Office Action Summary	Application No.	Applicant(s)	
	10/519,279	RODDIS, ALAN JAMES	
	Examiner	Art Unit	
	Vishal Patel	3676

DETAILED ACTION

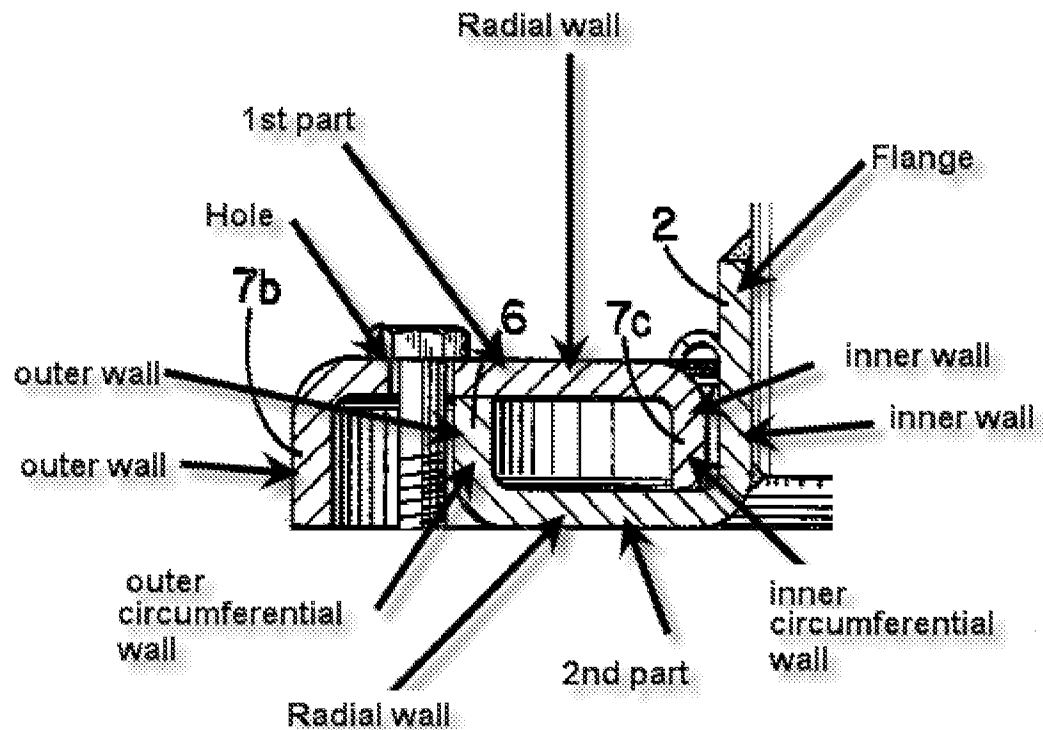
Schultz discloses a mechanical seal (figure 3) having a gland plate (7). The gland plate has structure claimed by applicant in claims 1-4, 6-12 and 14-15.

Schultz further discloses a gland plate having an annular first component having a radially extending wall with a thickness, an axially extending inner circumferential wall, an axially extending outer circumferential wall and at least one orifice, wherein the at least one orifice is formed in the radially extending wall of the first component and defined by an axially extending circumferential flange (see figure below that shows 1st part), a corresponding second component having a radially extending wall with a thickness, an axially extending inner circumferential wall, an axially extending outer circumferential wall and at least one orifice, wherein the at least one orifice is formed in the radially extending wall of the second component and defined by an axially extending circumferential flange (2nd part defined in figure below), wherein, when the respective inner circumferential walls and respective outer circumferential walls of the first and second components are brought into juxtaposition and held in engagement to form a hollow, annular structure, the respective orifices of the first and second components are aligned to form

at least one bolt hole and the respective circumferential flanges of the first and second components abut (intended use, the first and second part are capable of being juxtaposition).

Schultz discloses the claimed invention except that at least one wall has thickness of from about 0.4 to 1mm. Discovering an optimum range of a result effective variable involves only routine skill in the art. In re Kulling, 895 F.2d 1147, 14 USPQ 2d 1056. Without the showing of some unexpected result. Since applicant has not shown some unexpected result the inclusion of this limitation is considered to be a matter of choice in design. It would have been obvious to one having ordinary skill in the art at the time the invention was made to have a thickness chosen from 0.4 to 1mm to provide cost savings and provide mechanical expedience of the invention.

Fig. 2

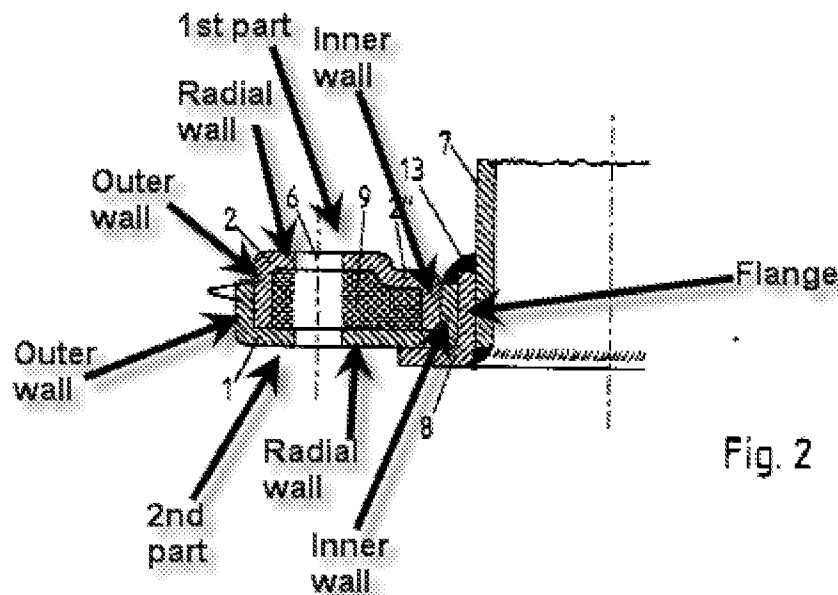
Kirchkamp discloses a mechanical seal (figure 2) having a gland plate (e.g. plate formed by 1, 2 and 9 attached to form a seal on 7). The gland plate has structure claimed by applicant in claims 1-4, 6-12 and 14-15.

Kirchkamp further discloses a gland plate having an annular first component having a radially extending wall with a thickness, an axially extending inner circumferential wall, an axially extending outer circumferential wall and at least one orifice, wherein the at least one orifice is formed in the radially extending wall of the first component and defined by an axially extending circumferential flange (see figure below that shows 1st component), a corresponding second component having a radially extending wall with a thickness, an axially extending inner circumferential wall, an axially extending outer circumferential wall and at least one orifice, wherein the at least one orifice is formed in the radially extending wall of the second component and defined by an axially extending circumferential flange (2nd component defined in figure below), wherein, when the respective inner circumferential walls and respective outer circumferential walls of the first and second components are brought into juxtaposition and held in engagement to form a hollow, annular structure, the respective orifices of the first and second components are aligned to form at least one bolt hole and the respective circumferential flanges

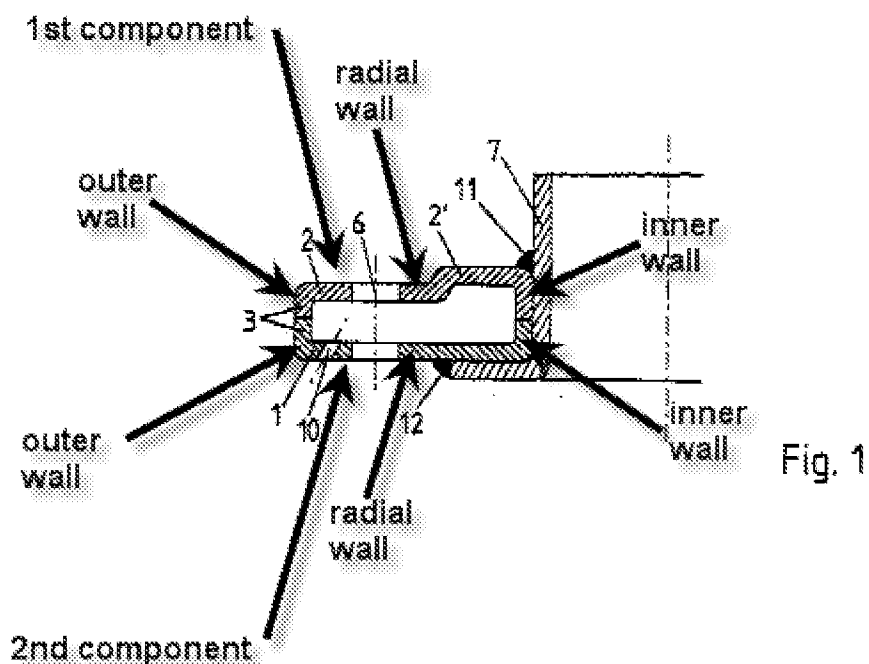
of the first and second components abut (intended use, the first and second component are capable of being juxtaposition). The flanges are defined by the inner walls that form the orifices.

Regarding limitations of claim 17: The respective inner circumferential walls and respective outer circumferential walls of the first and second components are held in engagement by crimping, adhering, chemically bonding and/or welding the walls together (the limitations formed by crimping, adhering, chemically bonding and/or welding are considered to be method limitations and given little patentable weight in an apparatus claims). Furthermore the first and second components are held in contact as seen in figure 1.

Kirchkamp discloses the claimed invention except that at least one wall has thickness of from about 0.4 to 1mm. Discovering an optimum range of a result effective variable involves only routine skill in the art. In re Kulling, 895 F.2d 1147, 14 USPQ 2d 1056. Without the showing of some unexpected result. Since applicant has not shown some unexpected result the inclusion of this limitation is considered to be a matter of choice in design. It would have been obvious to one having ordinary skill in the art at the time the invention was made to have a thickness chosen from 0.4 to 1mm to provide cost savings and provide mechanical expedience of the invention.
